Freightliner  
Service Bulletin

## General Information

**Fig. 1, Installing the Isolator**

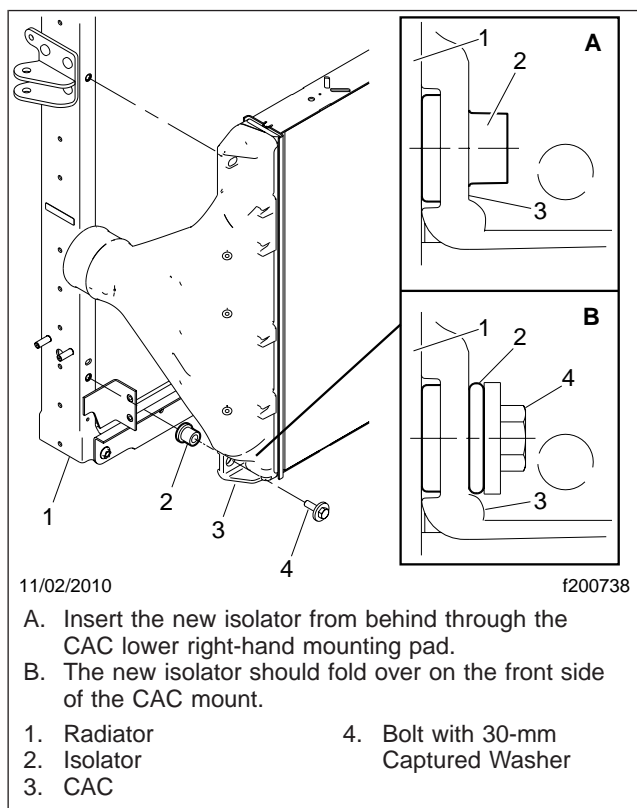
A new isolator and bolt with a 30-mm captured washer (hardware kit part number MOD 3S054916) is required when replacing the CAC, radiator assembly, or if the original right lower CAC mounting isolator is found to be deteriorated. The new isolator allows the CAC to "grow" under pressure.

1. Remove the grille.
2. Open the hood.
3. Remove the CAC flex hose on the right side.
4. Loosen all four CAC mounting bolts.
5. Remove the lower right-hand mounting bolt and isolator.
6. Insert the new isolator from behind through the CAC lower right-hand mounting pad. See [Fig. 1](#).
7. Hold the CAC firmly against radiator. See [Fig. 1](#)Detail A.
8. Start the new bolt with the 30-mm captured washer in the new isolator. Do not tighten at this time.
9. Start the other mounting bolts. Do not tighten at this time.
10. Verify the alignment of all four mounts, then, starting with the lower right-hand mounting bolt, tighten all four mounting bolts 26 lbf-ft (35 N·m).

The new CAC isolator should fold over on the front side of the CAC mount. See [Fig. 1](#)Detail B. If it does not, loosen all four of the mounting bolts and realign the CAC, then tighten it again.
